<b>PLAN COMMISSION AGENDA ITEM EXECUTIVE SUMMARY</b>			
	<b>Project Title/ Address:</b>	Concept Plan for 1915 W. Main Street (McDonald's)		
	<b>City Staff:</b>	Matthew O'Rourke, Planner		
<b>Please check appropriate box (x)</b>				
	<b>PUBLIC HEARING</b>		<b>MEETING (11/20/12)</b>	X
<b>APPLICATIONS UNDER CONSIDERATION:</b>				
Concept Plan				
<b>ATTACHMENTS AND SUPPORTING DOCUMENTS</b>				
Staff Memo; Dated 11/16/12		Concept Plan Application; Received 10/12/12		
Concept Plans; V3 Companies; Dated 11/15/12		Summary of Development V3 Companies; Received 10/12/12		
Parking Analysis; V3 Companies; dated 11/14/12				
<b>EXECUTIVE SUMMARY:</b>				
<p>The owner of the McDonald's restaurant located at 1915 W. Main Street is proposing to demolish the existing building and construct a new restaurant on this site. The details of the proposal are as follows:</p> <ul style="list-style-type: none"> <li>• Construct a new 5,234 square foot restaurant on the property. <ul style="list-style-type: none"> <li>○ The location of the restaurant will be further west on the property and oriented to be parallel with Rt. 64.</li> </ul> </li> <li>• Eliminate 2 of the 4 existing curbs cuts onto Rt. 64.</li> <

SHEET NO. **L1.0**

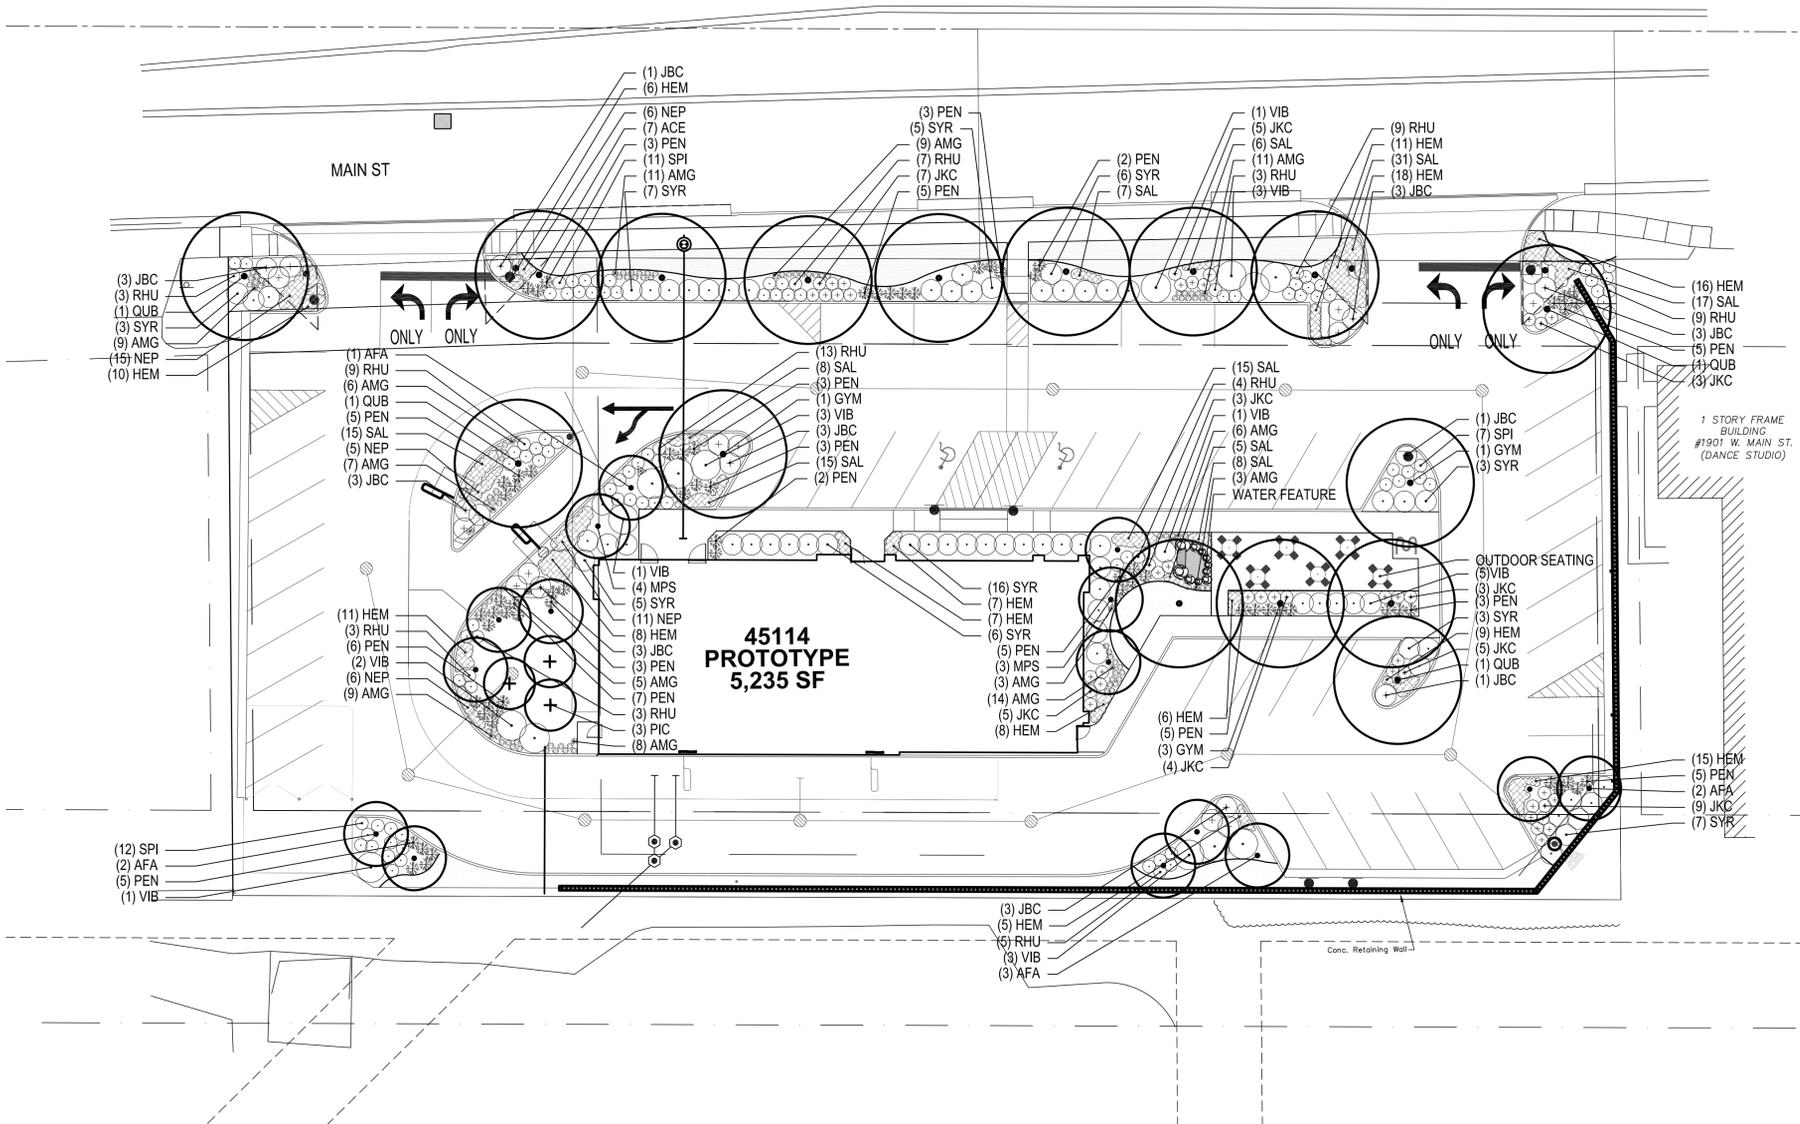
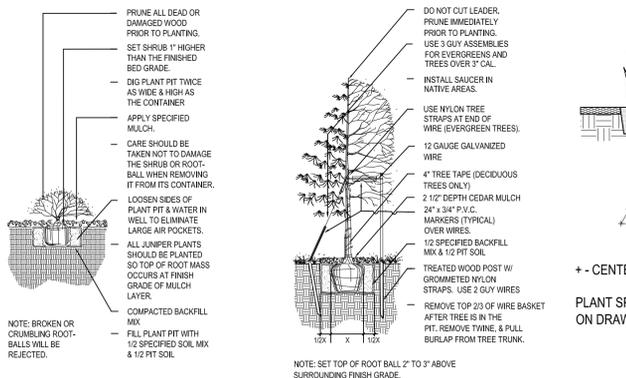
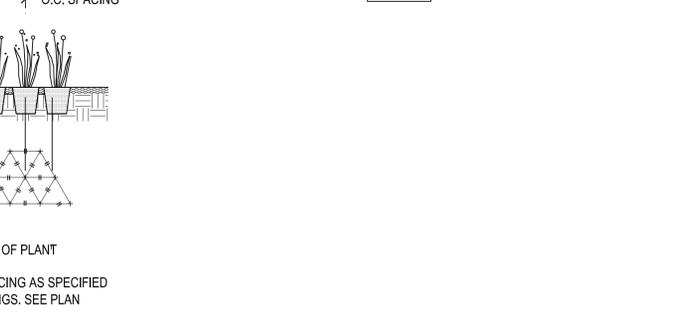
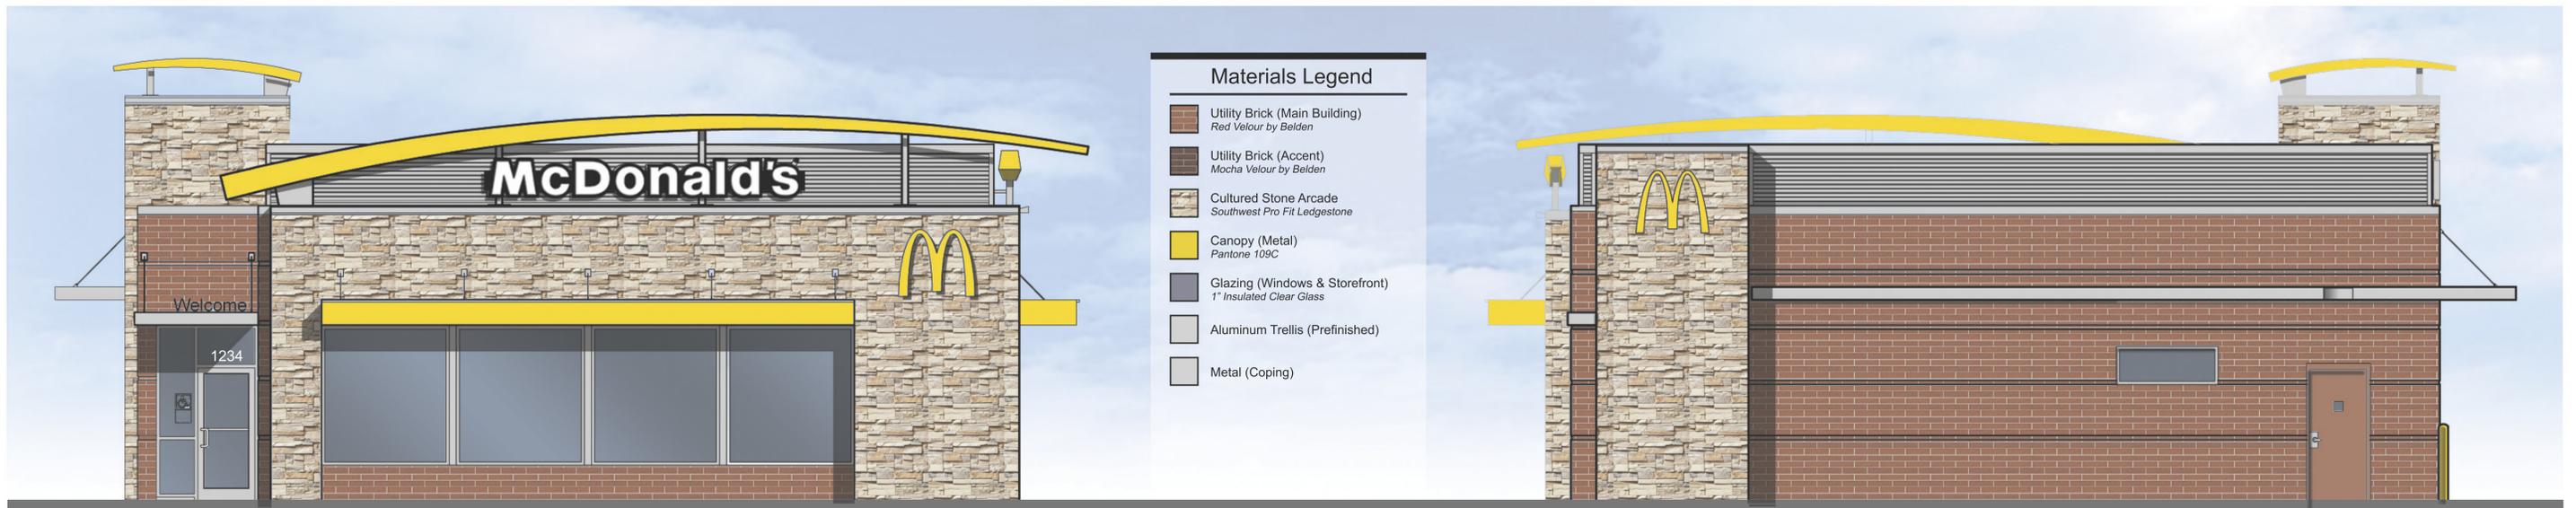
- There is a total 136.8 lineal feet of foundation landscaping required on the rear, left, and right facades, there is 128.3 lineal feet proposed.
- The applicant has proposed an increase of 4.25 lineal feet in excess of the 33.75 lineal feet of required foundation landscaping along the front or street facing façade.

- There are 12 ornamental or evergreen trees required along Rt.64, and 0 trees shown on the plans.
- 12 foundation landscaping trees are required and 11 are shown on the plans.

The applicant will need to meet these standards or request deviations from these standards through the PUD.
